DEVELOPMENT REVIEW COMMITTEE (DRC) COMMENT REPORT

PROJECT NAME: Fire Station #13

CASE NUMBER: PLN-SITE-20020002

REQUEST: Site Plan Level IV Review: Public Purpose Use for a Fire Station in the Central Beach Regional Activity Center

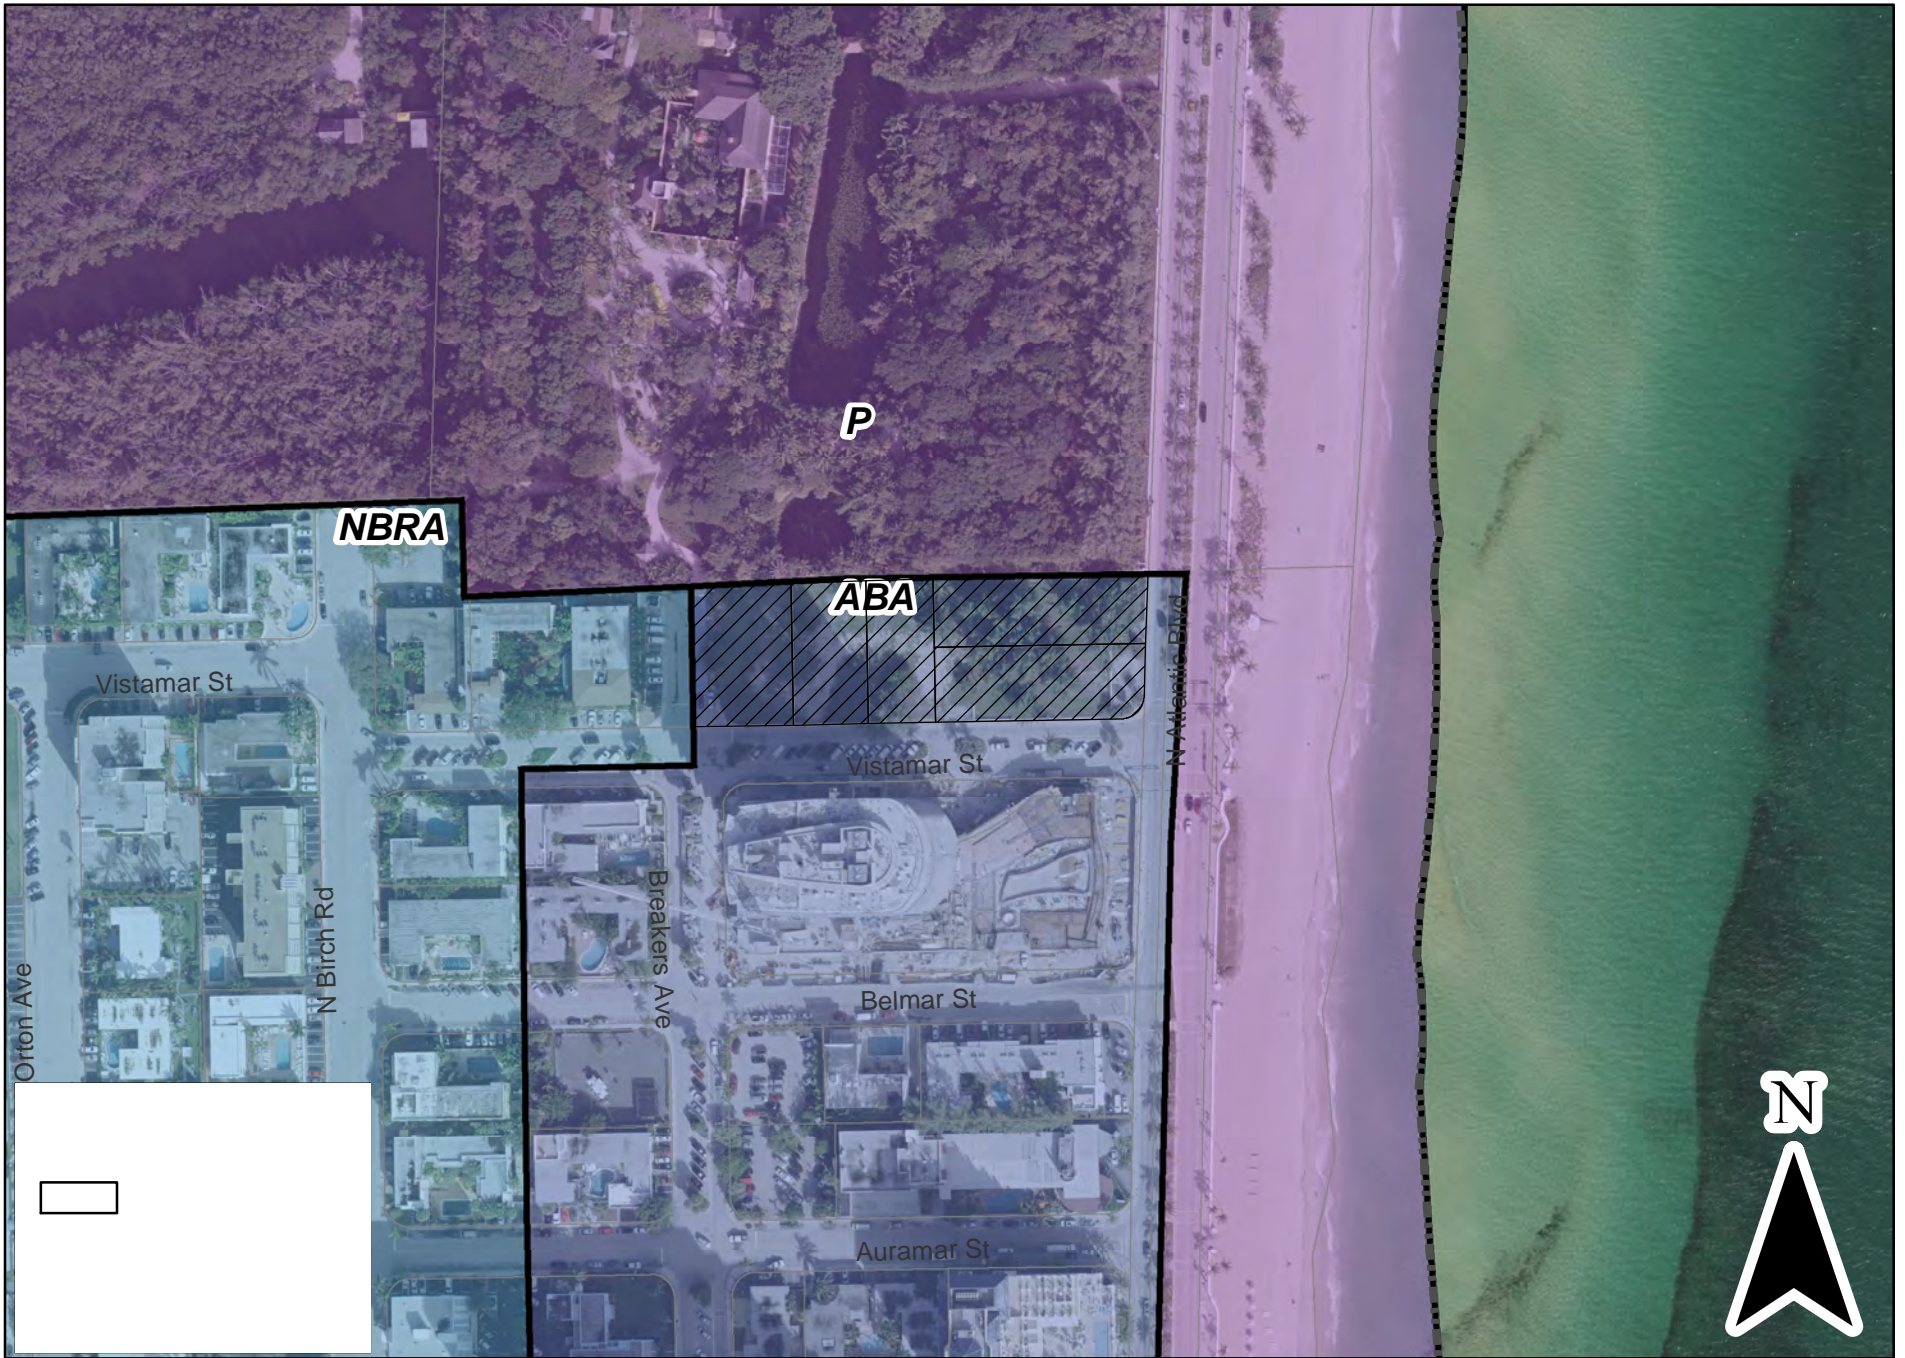
12. Provide a narrative including coordination on how the proposed project is consistent with the Breakers Avenue Streetscape Project. Information on the Breakers Avenue project can be found at: <https://www.fortlauderdale.gov/departments/transportation-and-mobility/transportation-division/construction-projects/breakers-avenue-streetscape-project>. Contact Karen Warfel (Email: kwarfel@fortlauderdale.gov, Phone: 954-828-3798, Transportation and Mobility Department Program Manager regarding coordination.
